Bharat Heavy Electricals Limited

ENQUIRY – Corrigendum		Phone: +91 431 257 1579 +91 431 257 1607	
Date: 26.08.2016		Email : krishnasamad@bheltry.co.in Web : www.bhel.com	
NIT No. 28962	Enquiry Number:	Enquiry Date:	Due date for submission of quotation:
E-Procure No. 2016_BHEL_139406_1	WCM/16-17/5006E	16.08.2016	10.09.2016 (Extended Due dt.)
This is only a request for quotation and not an order.

Description: Steam Generators (SG) Transportation through Hydraulic Axles (1 No. - 220 MT) from BHEL / Trichy to KAPP Site (Gujarat)

Details of Corrigendum

REV		DATE		ALTERED : SRK		W.O No. D131-D138		TITLE:		SK. NO.		REV	
01	04.01.13	CHD	APPD	RRV	SRK	DRN	RAMESH	700 MWe KAPP-3&4, RAPP-7&8		SK-3-D131-168		01	
NOTE 4 ADDED				CG OF SG REVISED				CHD		SOUGAT		LOADING DIAGRAM	
								APPD		A.S			
								DATE		18/10/13

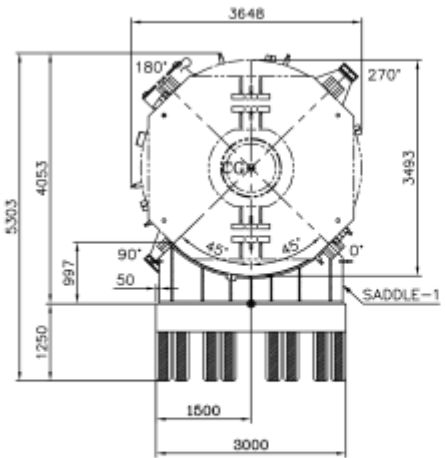
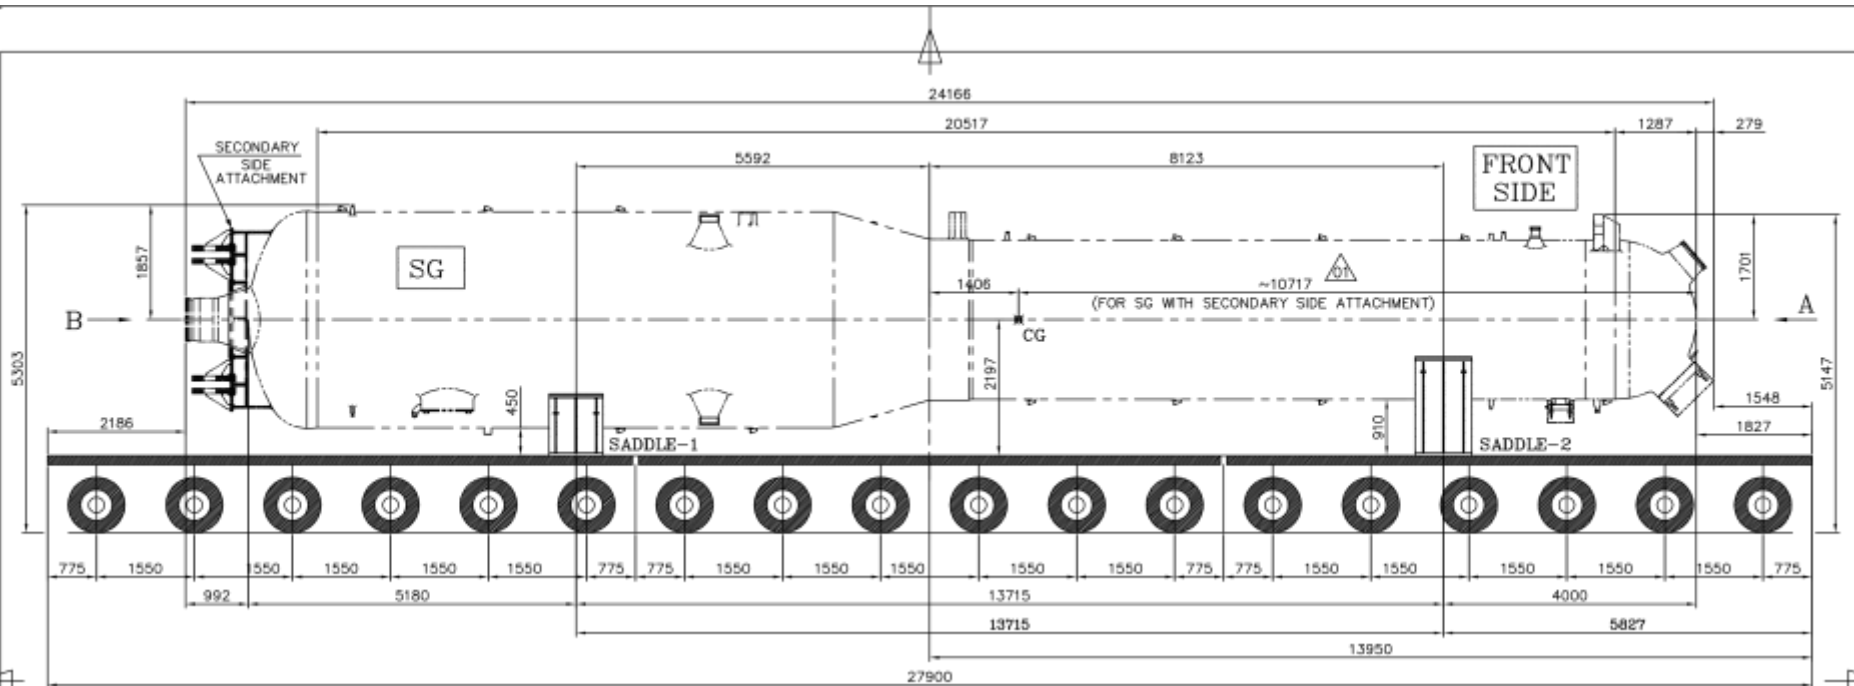
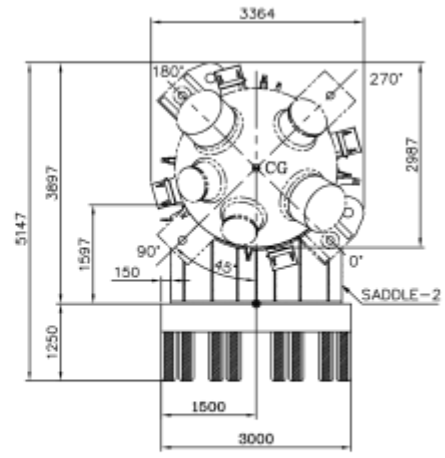
1. The revised Loading diagram is attached herewith and the same will be applicable for the transportation.
2. Vendor may opt for transportation of consignment with either 16 or 18 axles (as per Notes No. 4 of the Loading diagram), provided the consignment does not extend beyond the trailer platform on either side. The revised price bid format is attached.
3. If there is a discrepancy between words & figures in the rate quoted by any contractor, **the amount in words shall prevail**, unless the amount expressed in words is related to an arithmetic error, in which case the amount in figures shall prevail.
4. Readiness of SG - Feb-2017 (Tentative)
5. BHEL may opt Reverse Auction or Price Bids opening after evaluation of technical bids with prior intimation to the technically qualified transporters.

The above five points will be superseded all the clauses regarding number of axles required for transportation and the Loading diagram given in the earlier tender schedule.

1. AVOID JERK DURING TRANSPORTATION
2. PROPER FASTENING OF STEAM GENERATOR (SG) WITH VEHICLE HAS TO BE ENSURED
3. STEAM GENERATOR + SADDLES WEIGHT : ~ 228 TONNES
 (STEAM GENERATOR : 214 TONNES
 SECONDARY SIDE ATTACHMENT : ~ 7 TONNES
 SADDLE-S1 : ~ 3.8 TONNES &
 SADDLE-S2 : ~ 2.7 TONNES)
- △ 4. 16 AXLES TRAILER IS ALSO PERMITTED, PROVIDED THE EQUIPMENT DOES NOT EXTEND BEYOND THE TRAILER PLATFORM ON EITHER SIDE
